**PACIFIC GAS AND ELECTRIC COMPANY'S (U 39 E)
INDEPENDENT PROFESSIONAL ENGINEER PG&E 2025
DISTRIBUTION PLANNING ADVISORY GROUP REPORT**

(PUBLIC VERSION)

ATTACHMENT A

Figure 6-2: Comparison of IEPR Forecast with DPP Forecast for EV Loads

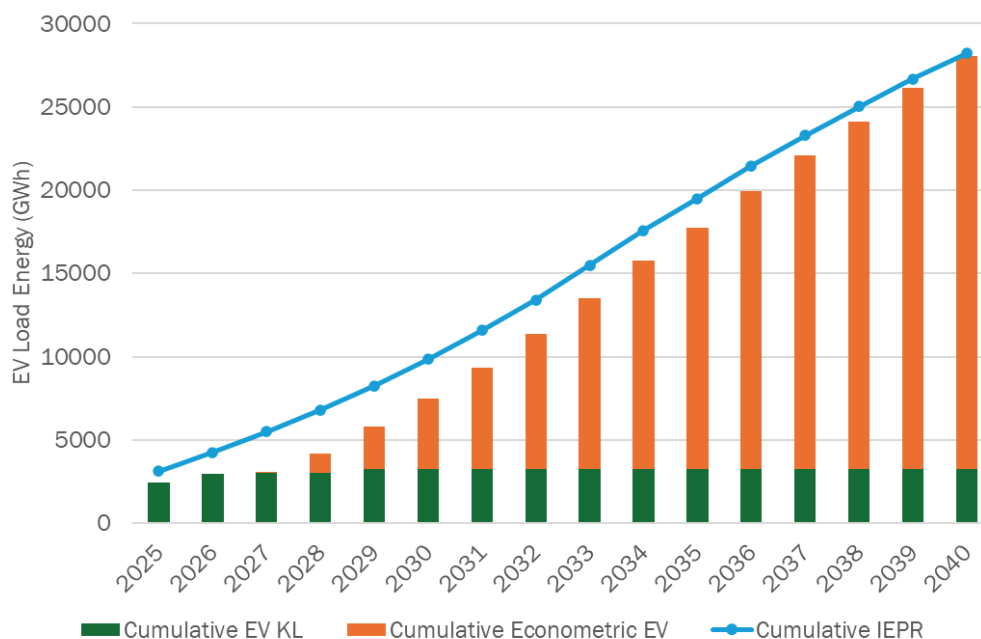
PG&E uses a comprehensive methodology (same as the one used in the last cycle) to reconcile the difference between the IEPR LDEV and MDHDEV forecast and EV Known Loads in order to determine the Econometric (spatial) EV growth forecast that needs to be included in the forecast. This process is described in detail in Appendix C.5 of PG&E’s GNA report. The IPE was able to verify that on an energy basis, the IEPR forecast for EVs matches with what was used in the DPEP. Figure 6-2 shows the cumulative energy from EV Known Loads and EV Econometric Loads used in the DPEP. The sum of these two matches closely with the IEPR forecast on a cumulative energy basis as seen from the figure.

Figure 6-18: Comparison between Actual versus Forecasted 2024 Peak Load from Extreme Load Profile

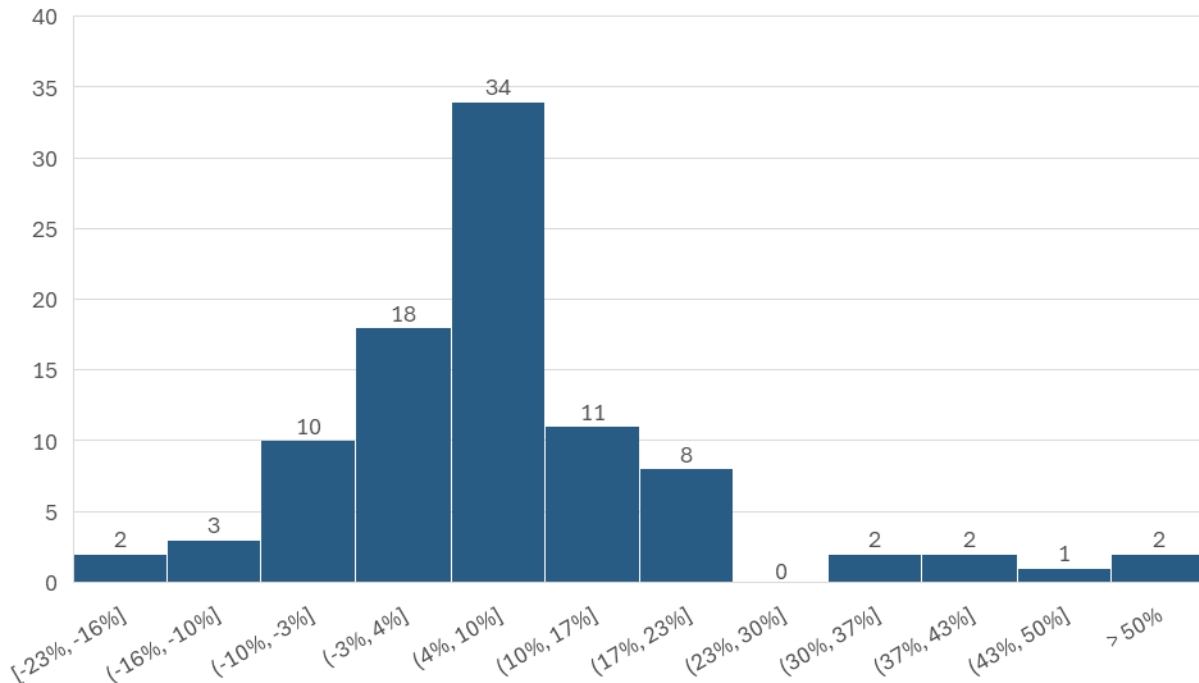
Verification: The IPE obtained the forecasted 2024 peak load (peak of the extreme profile) from the 2024 GNA report which was used for planning in the last cycle. PG&E also provided the actual 2024 peak load for all the circuits. Please note that the actual 2024 peak load was not adjusted to extreme weather conditions. The IPE made a comparison between the two for each feeder in PG&E's system as shown in Figure 6-18. This histogram shows the forecast error (forecast minus actual/forecast) from which it can be seen that there are more feeders where the forecast is higher than actuals. This is because we are comparing an extreme peak load forecast against actual peak load. The IPE plans to review this step in the next cycle and make adjustments as needed based on the availability of data to perform this verification as intended.
